Re: HECA PDOC Comments

Enclosed are the Applicant's comments on the SJVAPCD Preliminary Determination of Compliance.

**Comments on the Preliminary Determination of Compliance
 Hydrogen Energy California (08-AFC-8A)
 [May 16, 2013]**

Figure 6-5 Onsite Structures (Blue Objects)

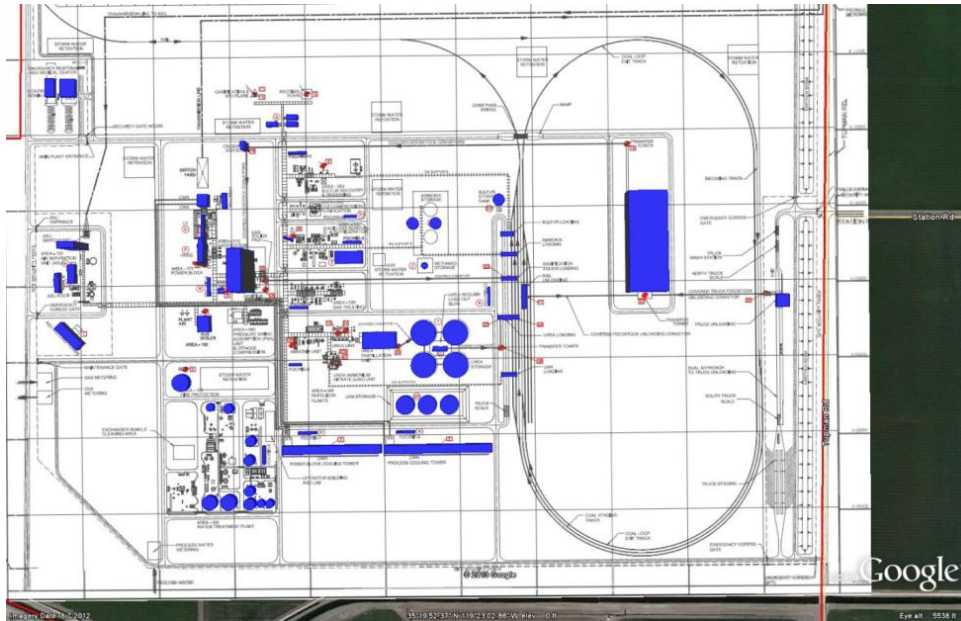
197	Section 6.5.6	Page 19		GEP Analysis was redone with new project information, and therefore these statements will need to be updated as a result. Please refer to the updated emissions and modeling report.
198	Section 6.5.6	Page 20	Figure 6-5	Figure will need to be updated with new project information and plot plan. Please refer to updated modeling files submitted with the updated emissions and modeling report.
199	Section 6.6.1	Page 20-21	Table 6-4	Project Emissions need to be updated with new project information. Please refer to the updated emissions and modeling report. Please consider changing the title of the table to: “Table Error! No text of specified style in document. -1 Criteria Pollutant Emitted Compared to PSD Significance Thresholds”

Figure 8-2 Onsite Structures (Blue Objects)

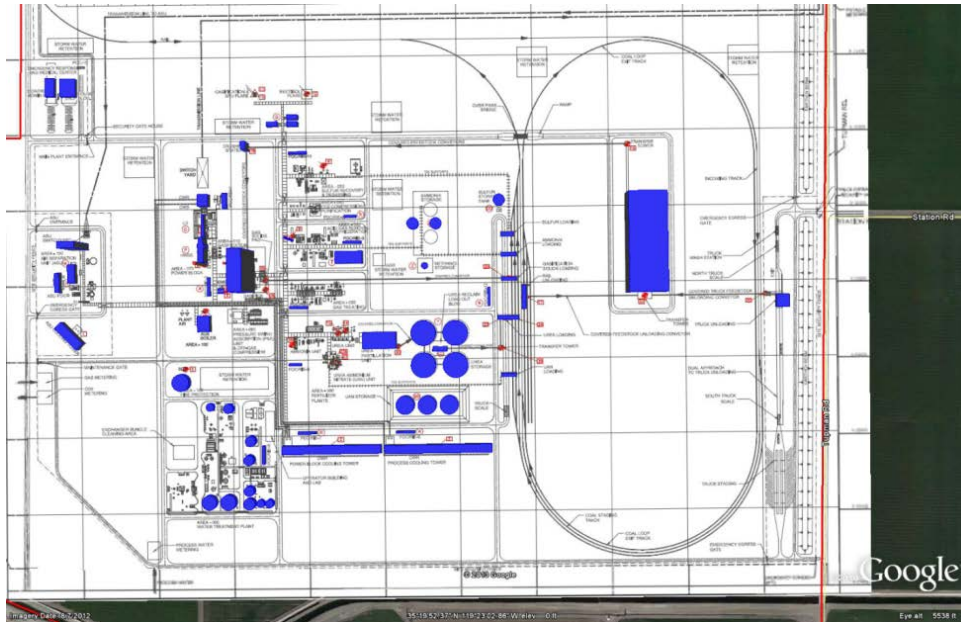
Comment Number	PDOC Section Title	PDOC Page Number ¹	PDOC Statement ²	Comments to San Joaquin Valley Air Pollution Control District ³
216	Section 8.2.7	Page 44	Figure 8-2	Figure is the same as Figure 6-5. See comments for Figure 6-5 above and apply to this figure as well.
217	Section 8.2.8	Page 44-45	Table 8-3	The permit ID and Lbs/Day for the equipment have changed based on new project emissions. Please refer to updated emissions and modeling report.
218	Section 8.2.9.1	Page 47	Table 8-4	Table is the same as Table 6-7. See comments for Table 6-7 above and apply to this table as well.
219	Section 8.2.9.2	Page 49	Table 8-5	<p>Please explain the modeling that was conducted to get the modeled impact of 111 $\mu\text{g}/\text{m}^3$ (27) for NO₂, 1-hour and why Project Impact Significant AAQS = Yes. NO₂ modeled impacts for CAAQS and NAAQS were determined to be insignificant.</p> <p>HECA will not have a significant PM₁₀ AAQS impact because the area is in attainment for the federal standards and modeled impacts are less than the SILs, plus HECA is offsetting PM₁₀ emissions.</p> <p>HECA will not have a significant PM_{2.5} AAQS/SIL impact because HECA is obtaining offsets.</p> <p>Please update modeled impacts from the updated emissions and modeling report.</p>
